Re: Response to Comments for LOMR for Brickhouse Gully;  
City of Houston  
Brickhouse Gully (E115-00-00)

Below are our responses to the second HCFCD courtesy review comments for the LOMR for Brickhouse Gully dated March 4, 2014.

Below are our responses to the third HCFCO courtesy review comments to the LOMR for Brickhouse Gully dated April 4, 2014.

Approximate locations of Manning' n of .99 used along Brickhouse Gully.

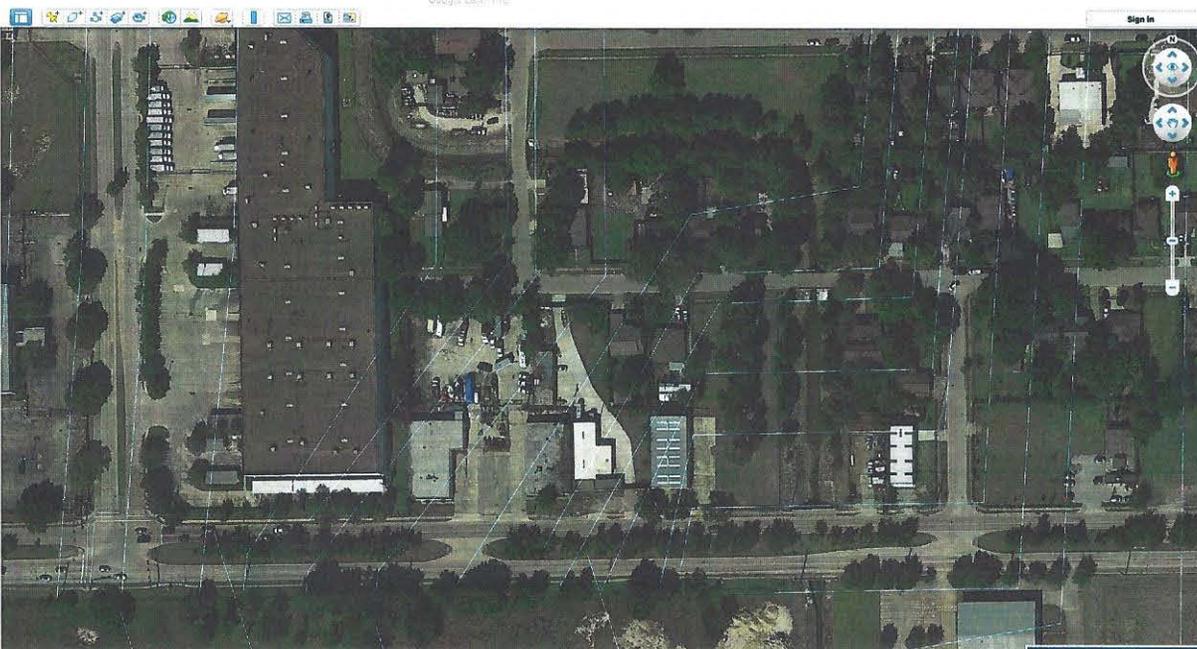
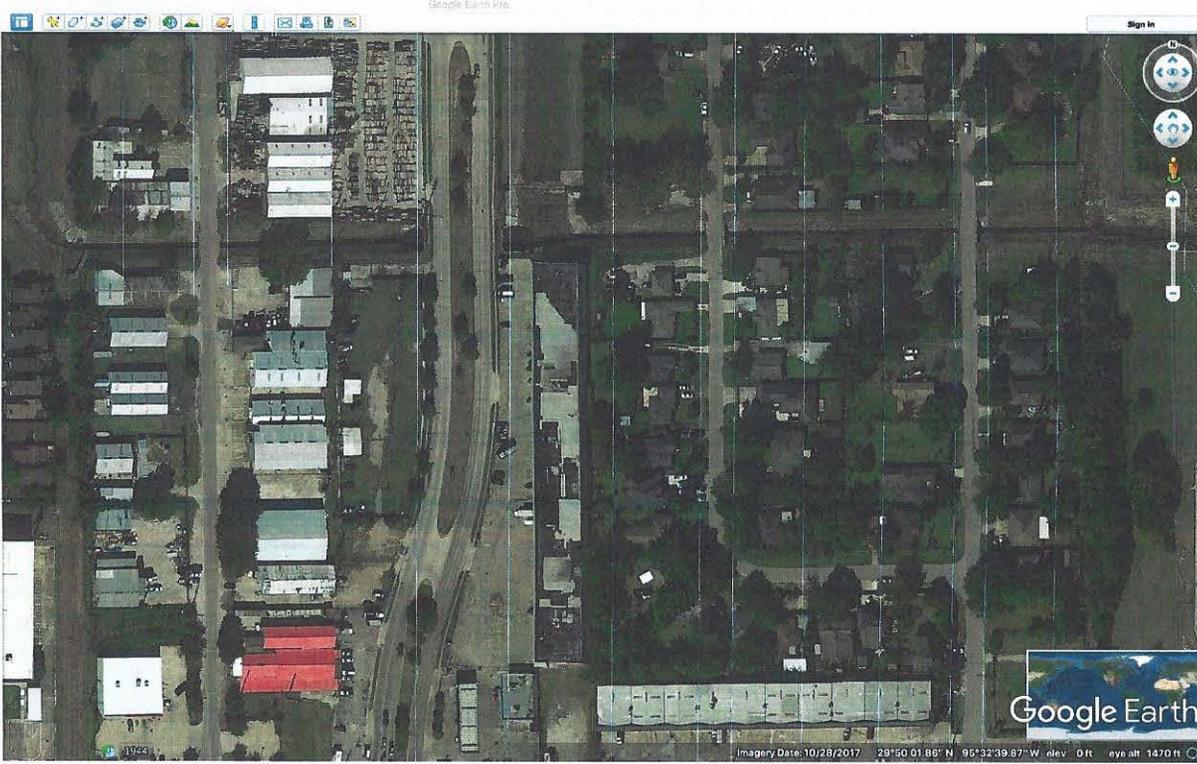
2. **Comment:** Please provide justification for the changes in manning's n and explain based on your XP model.

**Response:** The manning's n values were modified in the right overbank areas of the Brickhouse Gully model from river stations 32382.3 to 26768.1 to reflect the existing land use in these areas. The commercial and residential areas between Brickhouse Gully and Gessner Road were given a manning's n of 0.99 based on how the commercial and residential structures will restrict conveyance in these areas. Gessner Road right-of-way was given a manning's n of 0.015. The Pine Crest golf course area was given a manning's n value of 0.05 as the golf course grasses are cut relatively short in regular golf course maintenance and allow for less obstructed flow than in typical overbank areas.

PHOTO OF West Side of City/TIRZ 17 BRIDGE

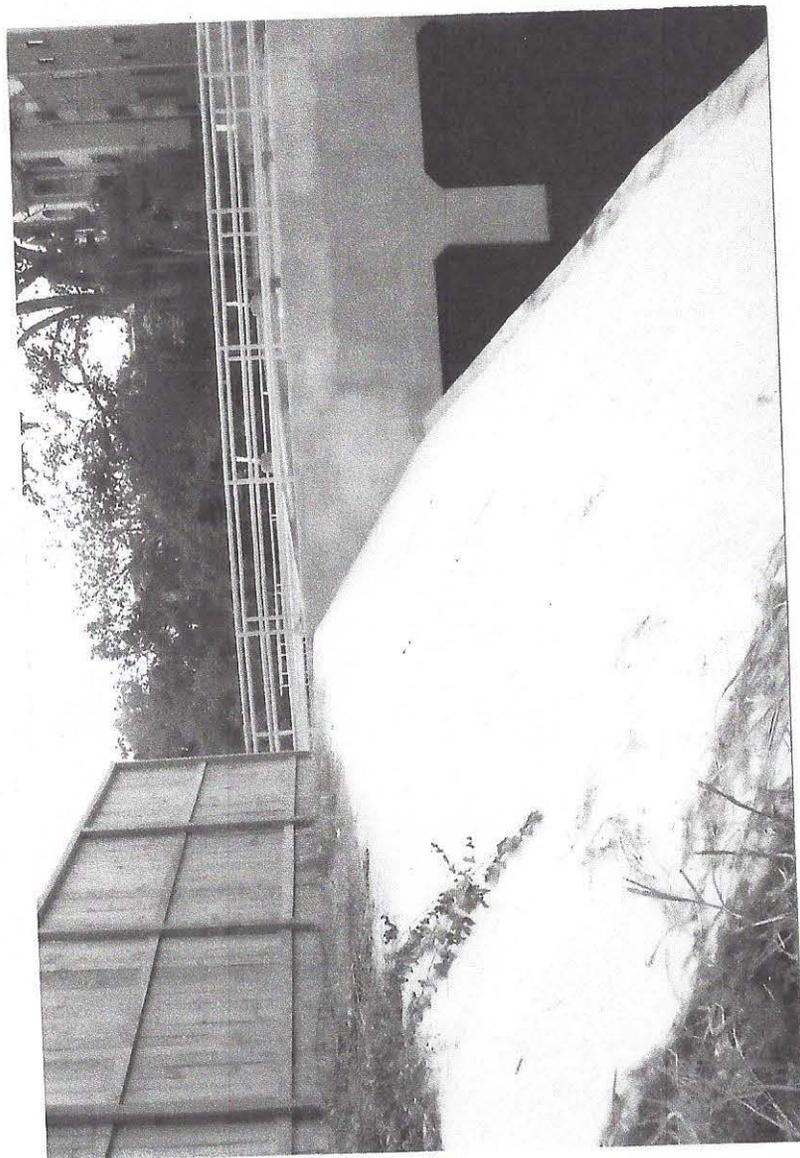
Re-DONE on Flawed Engineering  
Study OF 2007 & REBUILT  
with this Study in 2009.

Acts now as a dam,  
preventing water to flow  
under it by 3 TIMES the  
amount that previously  
flowed under it & went  
out to sea. Now Too Small.

THUS, MASSIVE FLOODING OCCURS  
now in Homes/Streets.  
CITY & COUNTY APPROVED THIS.
